SYNOPSIS OF REVISIONS INCLUDED IN WATTS BAR NUCLEAR PLANT UNIT 2 DEVELOPMENTAL REVISION H OF THE TECHNICAL SPECIFICATIONS AND TECHNICAL SPECIFICATION BASES

**TENNESSEE VALLEY AUTHORITY
WATTS BAR NUCLEAR PLANT, UNIT 2**

**Revisions to Developmental Technical Specification (TS)
and Technical Specification Bases (TSB) Revision H**

Technical Specification Changes (Mark-Up) for WBN Unit 2

FIGURE 4.3-3
MINIMUM REQUIRED BURNUP FOR UNRESTRICTED STORAGE
OF ~~NEW AND SPENT~~ FUEL OF VARIOUS INITIAL ENRICHMENTS

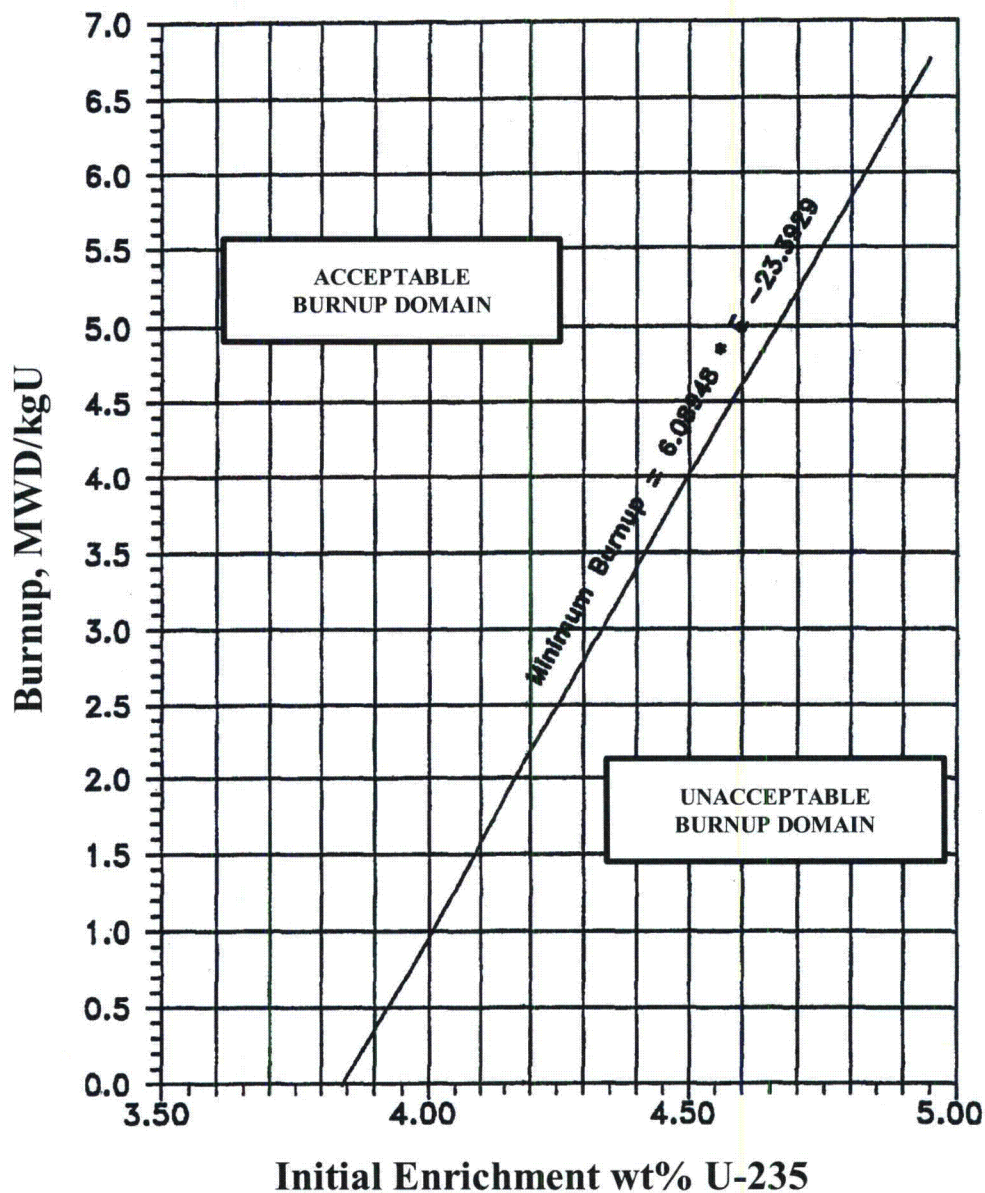
1. ~~New and spent-f~~Fuel assemblies may be stored in the racks in an all cell arrangement provided the burnup of each assembly is in the acceptable domain identified in Figure 4.3-3, depending upon the specified initial enrichment.

FIGURE 4.3-4
MINIMUM REQUIRED BURNUP FOR A CHECKERBOARD ARRANGEMENT OF 2 SPENT
AND 2 NEW FUEL ASSEMBLIES OF 5 wt% U-235 ENRICHMENT (MAXIMUM)

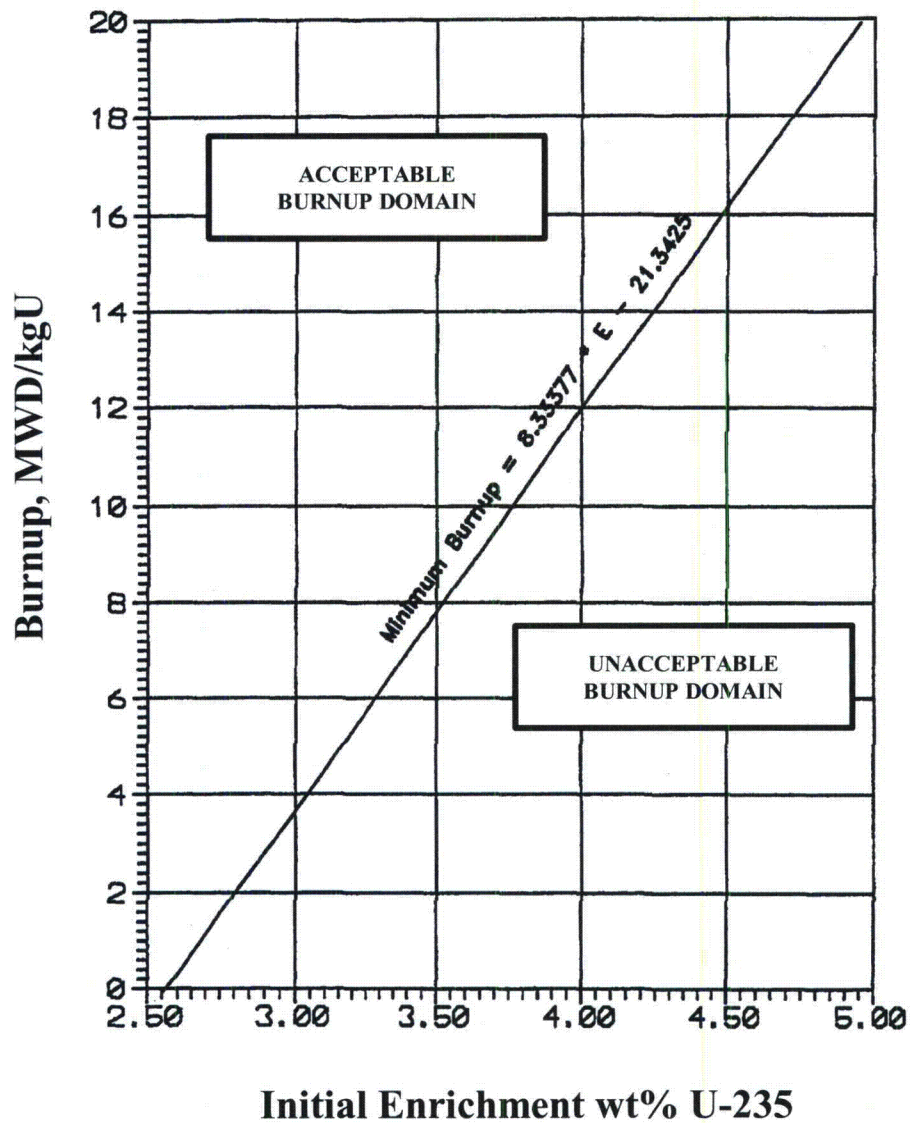
2. New and spent fuel assemblies may be stored in a checkerboard arrangement of 2 new and 2 spent assemblies, provided that each spent fuel assembly has accumulated a minimum burnup in the acceptable domain identified in Figure 4.3-4.
